Public Comment No. 894-NFPA 70-2021 [Global Input]

Public Comment No. 1220-NFPA 70-2021 [Definition: Branch Circuit, Appliance.]

Figure 2

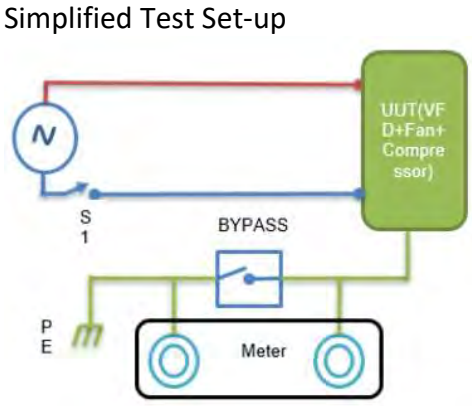
Simplified Test Set-up (see attached figure#2)

Figure 4: 14/2 CCA Spaced 12" in R43 Insulation at 10 Amps in Ceiling Configuration

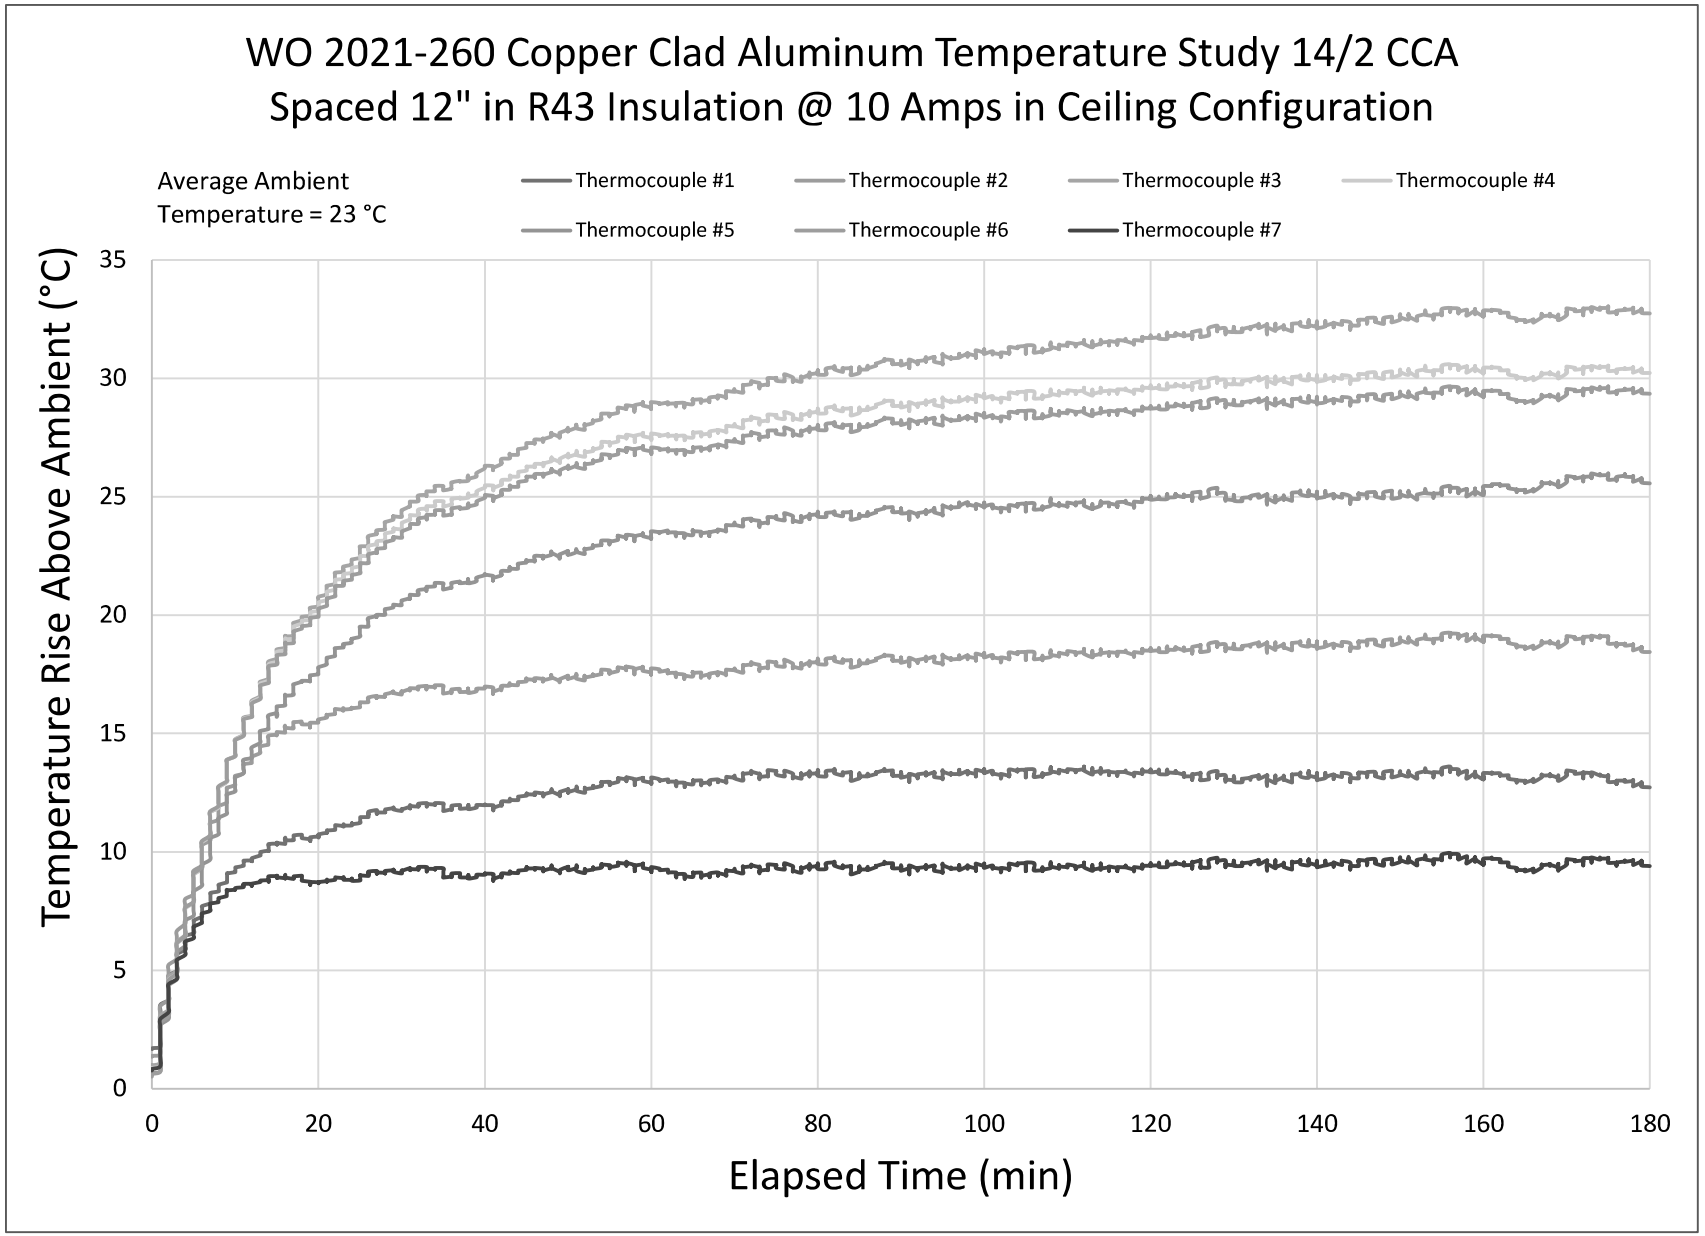
See Figures 4 and 5 below for the temperature profile for AWG 14/2 copper-clad aluminum and 14 AWG THHN copper-clad aluminum while the apparatus was in the ceiling orientation. See Figures 6 and 7 for data in the wall orientation.

Figure 210.52(C)(2) Determination of Area Behind a Range, Counter-Mounted Cooking Unit, or Sink.

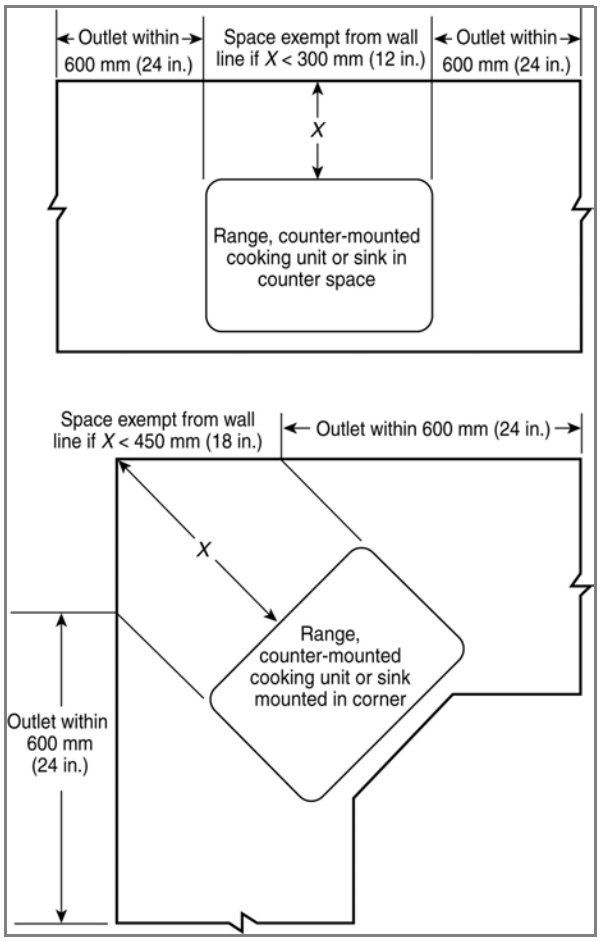
Exception No. 2 Where a required receptacle outlet cannot be installed in the wall areas shown in Figure 210.52(C)(2), the receptacle outlet shall be permitted to be installed as close as practicable to the countertop area to be served. The total number of receptacle outlets serving the countertop shall not be less than those required in 210.52(C)(2). These outlets shall be installed in accordance with 210.52(C)4(1) or 210.52(C)4(2).
